Service Bulletin

PRELIMINARY INFORMATION

Involved Region or Country	North America
Additional RPO/s:	N/A
Condition	Front Of Seat Cover Comes Loose
Cause	Seat Frame Hem Flange Too Wide.

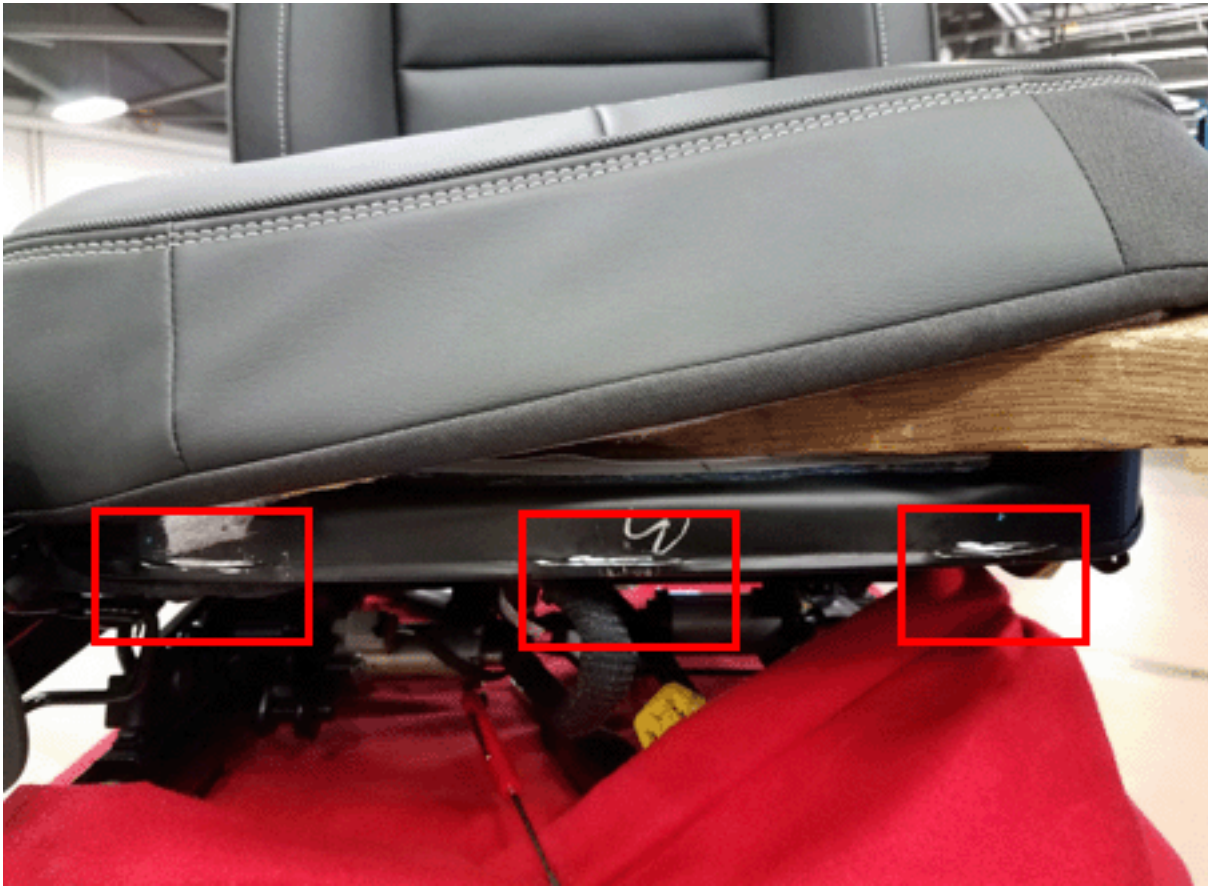
Adjust the seat pan hem flange as illustrated below.

First remove the effected seat and place on a suitable surface with the front of the seat facing toward you. Raise the front of the seat cover, lift the cushion and support with a board or block.

Entirely or partially remove the outboard trim cover and create clearance to the outer corner of the cushion pan hem surface (passenger seat shown).

Using a pair of calipers set to 5 mm , mark the cushion pan flanges in the 3 areas where the profile is protruding away from the rest of the cushion pan (hem fold is open in these locations, not tight to the structure)

Use a die grinder and cutting wheel to remove material, reducing the hem height to the 5 mm as previously measured. It's important to remove the material across the entire length of the 3 portions of the flange not folded tightly upon itself.

Again using the calipers check to make sure the flange in the areas cut is between 4-5.5 mm, if not, continue removing material until this condition is met. Use a deburring tool, pick or small screwdriver to ensure there's no debris, burrs, or other material inside the open areas of the cushion flange that have been cut. Depending on the cut, a tool may be needed adjust the hem back out so that the barb on the plastic J retainer can engage.(1)
